## Detailed Site Plan Junica Brandywine

## DET-2025-006

SUBJECT: Detailed Site Plan DET-2025-006  
Type 2 Tree Conservation Plan TCP2-2025-0061  
Junica Brandywine

# DETAILED SITE PLAN

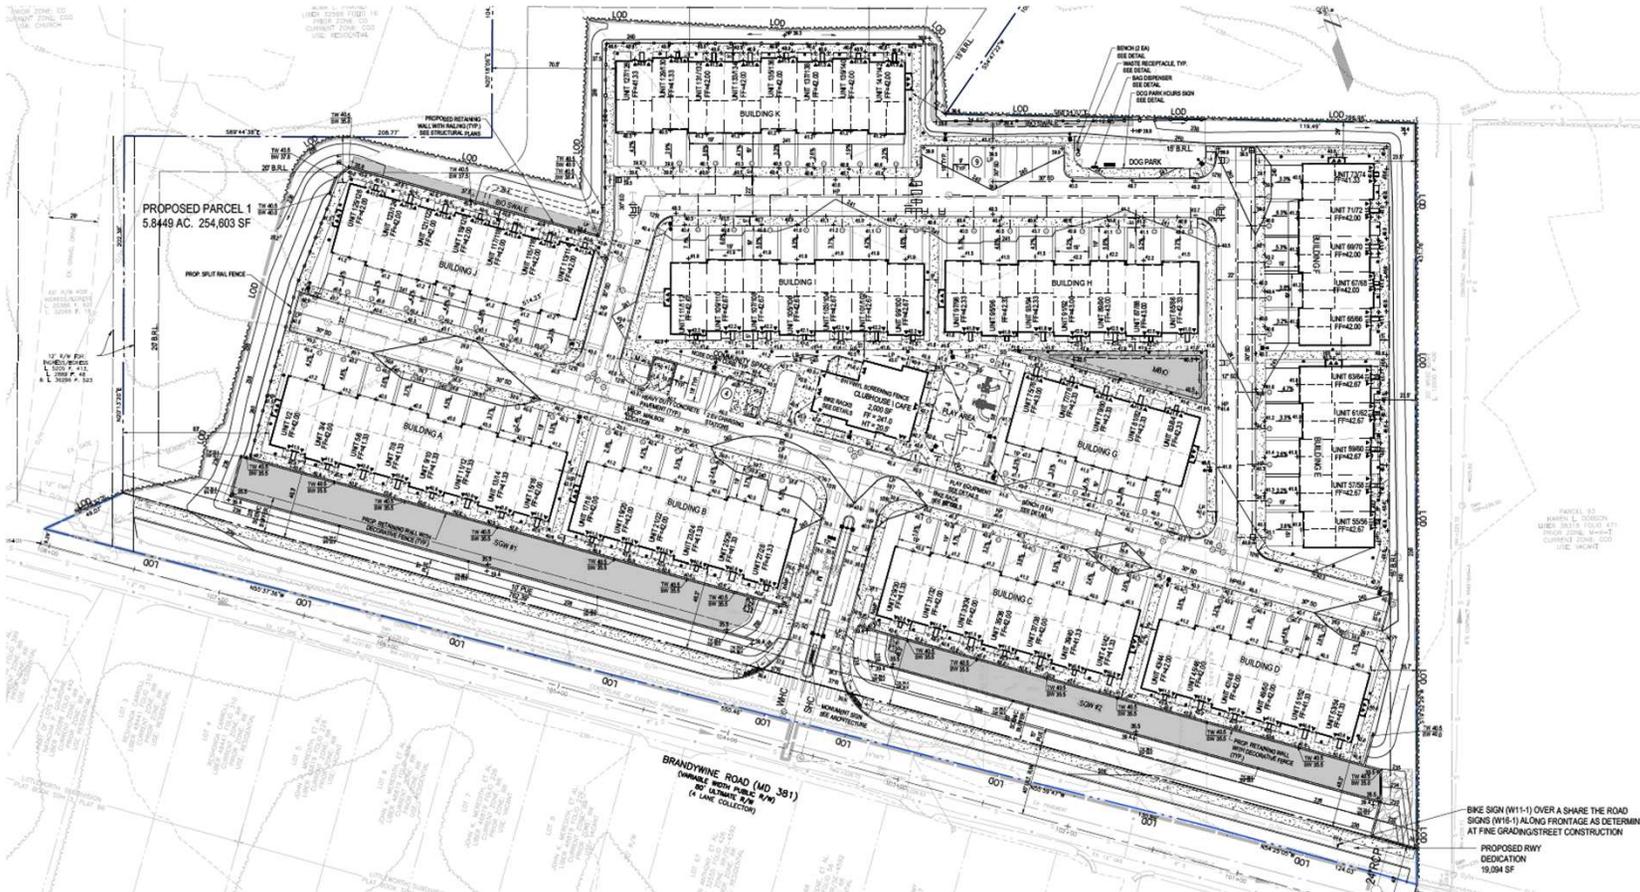
The submitted plans demonstrate circulation for multiple travel modes (pedestrian, bicycle, and vehicle) throughout the site. Staff recommend ADA curb ramps at vehicular crossings, and bicycle parking be provided to support multimodal use.

along the property frontage of MD 381. Staff recommend that the applicant provide clarity for the dimensions of the pedestrian facilities on the site plan to ensure they meet the 5-foot-width.
